ADDENDUM NO. 1

**Upgrade/Improve Electrical
Swine Pavilion, Missouri State Fairgrounds
Sedalia, Missouri
PROJECT NO.: F1904-01**

Bid Opening Date: 1:30 PM, Thursday, September 5, 2019 (Not Changed)

SD-EP-104

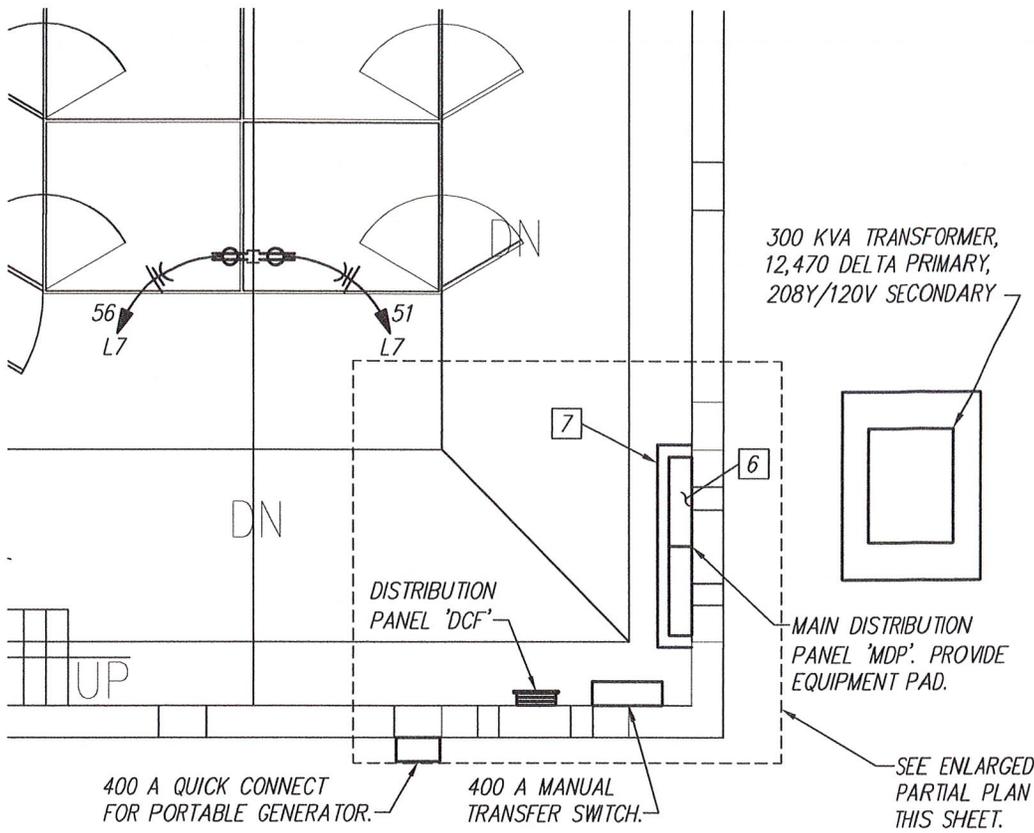
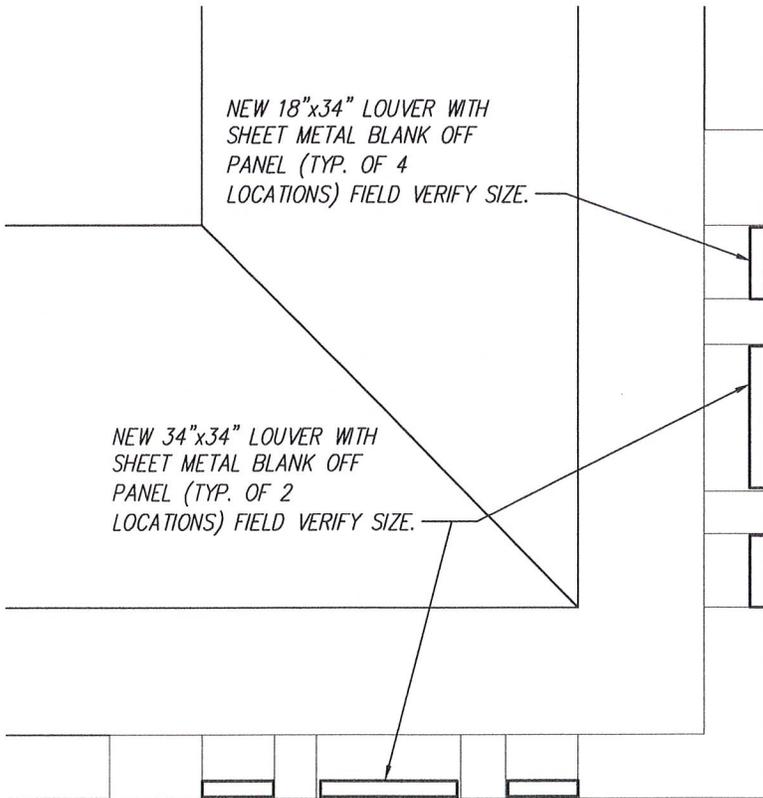
- a. ADD the new louvers indicated for the existing window openings at the southeast corner of the building per attached Supplemental Drawing SD-EP-104.
